January 15, 2009

DNR File No. DC-0128

Subject: Amendment to the *Dane County Water Quality Plan*, Revising the
Mt. Horeb Urban Service Area Boundary and Environmental Corridors in the
Village of Mt. Horeb, Town of Springdale and Town of Blue Mounds.

Map 1 Revision
 Amendment to the
 Mt Horeb Urban Service
 Area in the Village of Mt
 Horeb, Town of Blue
 Mounds and Town of Springdale

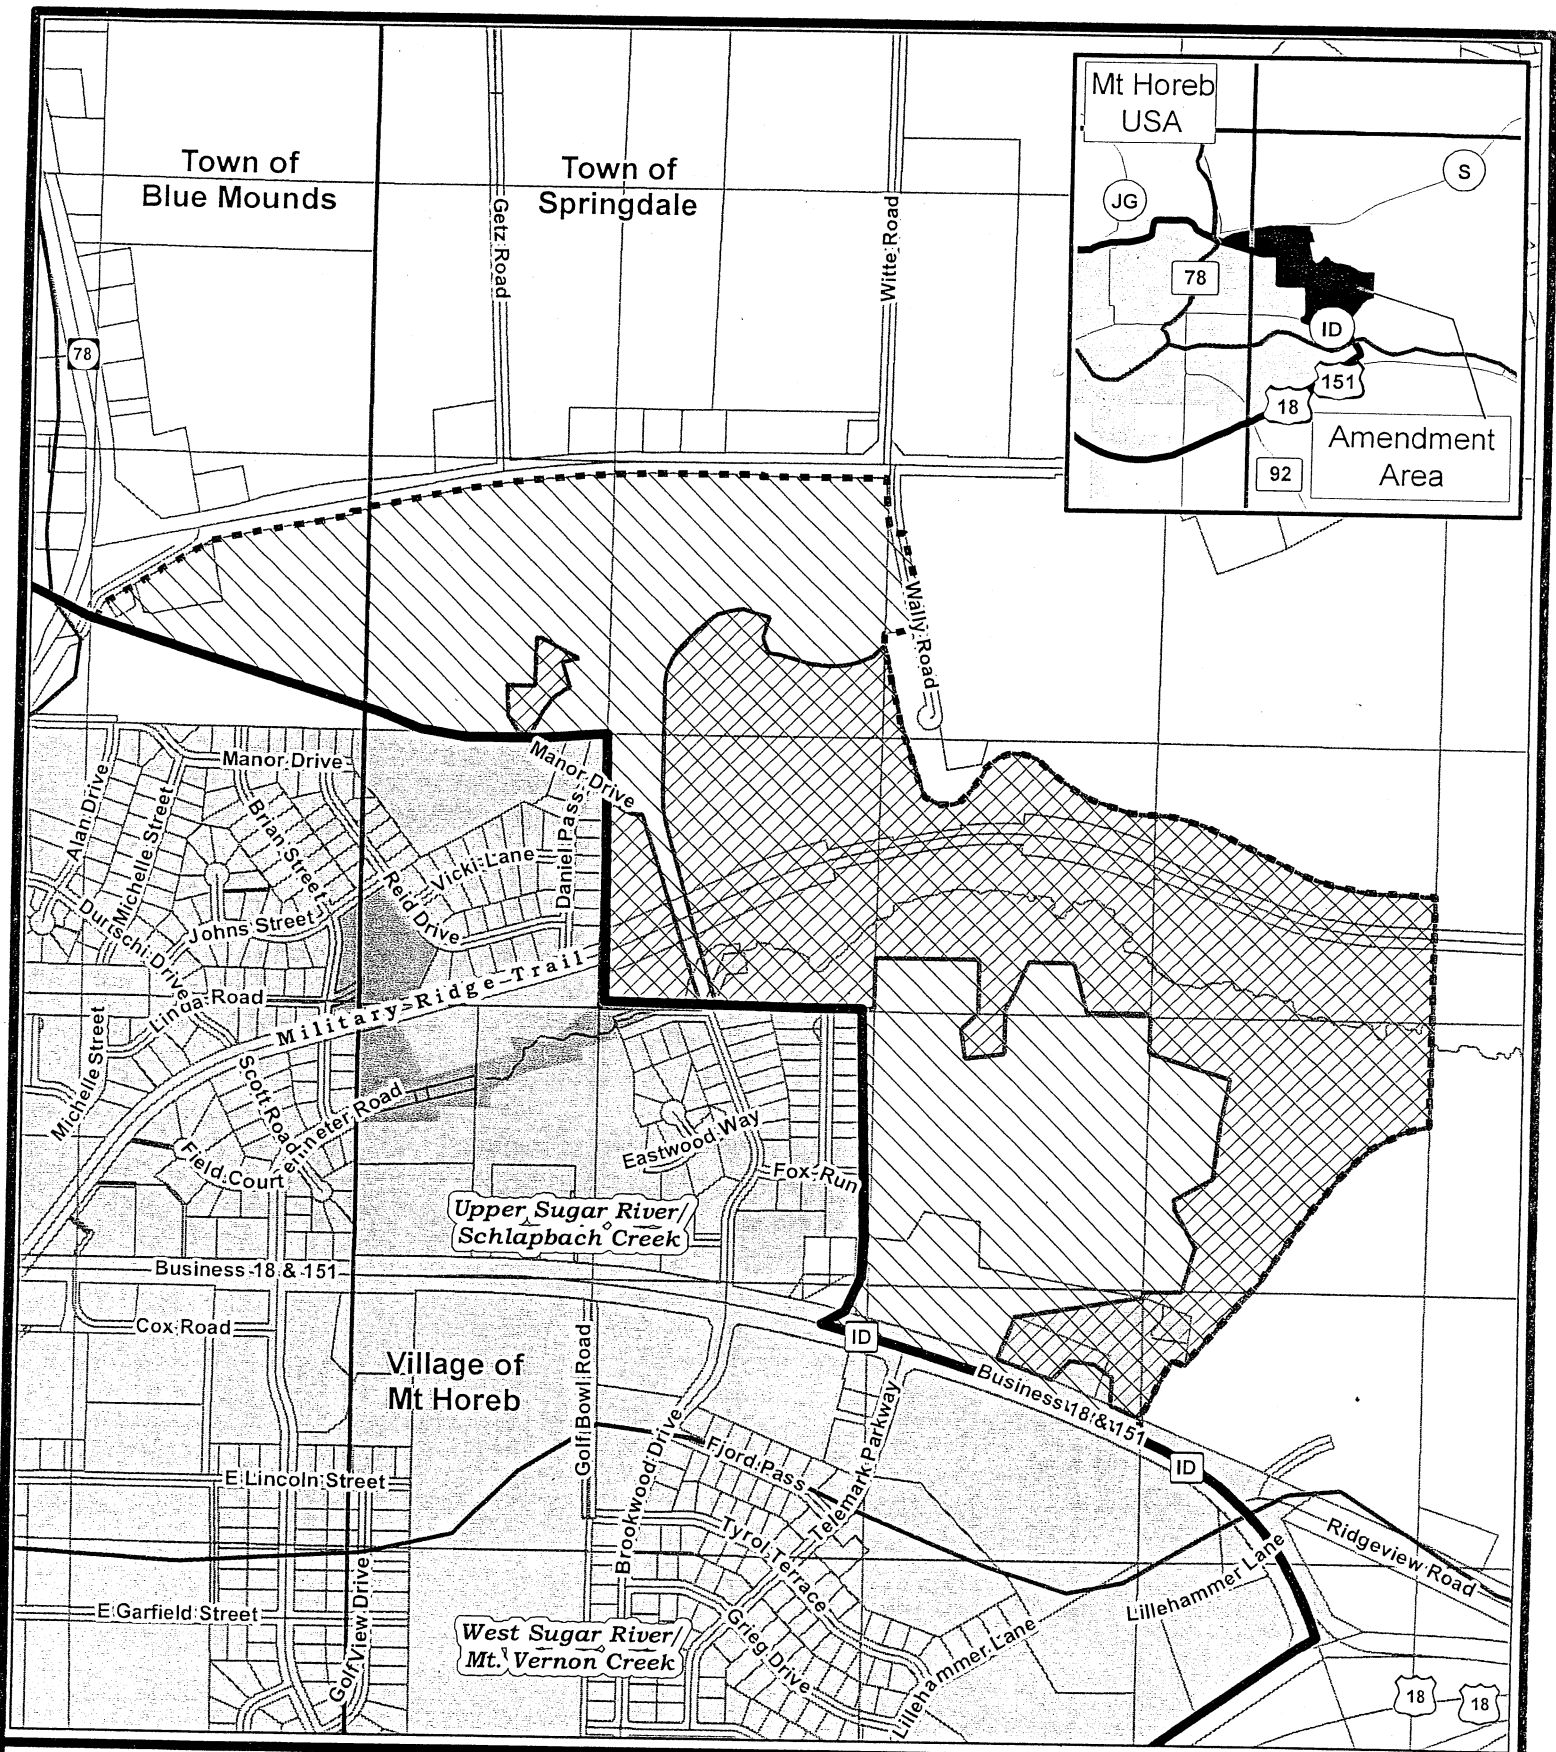
We have completed our review of the subject amendment request that was submitted to the Department on November 10, 2008 by the Capital Area Regional Planning Commission. The Department hereby approves this amendment request which adds 276.9 acres to the Mt. Horeb Urban Service Area, including 13.5 acres of existing development and 119.7 acres of environmental corridors, with a net developable area of 143.7 acres.

The amendment area is located on the northeast side of Mt. Horeb, south of CTH S and north of CTH ID and includes land in the Town of Springdale, in the Town of Blue Mounds and in the Village of Mt. Horeb. (See Revised Map 1).

This Department approval is subject to the condition that the Village of Mt. Horeb comply with the conditions stated in Resolution CARPC No. 2008-17 as follows:

6. The proposed environmental corridors shall be substantially retained. Any major encroachment into the corridors is presumed to have adverse water quality impacts due to the presence of steep slopes, stream buffers, and woodlands. The minimum stream buffer with native vegetation is 200 feet in the northwest corner of the Schroeder portion of the amendment area.
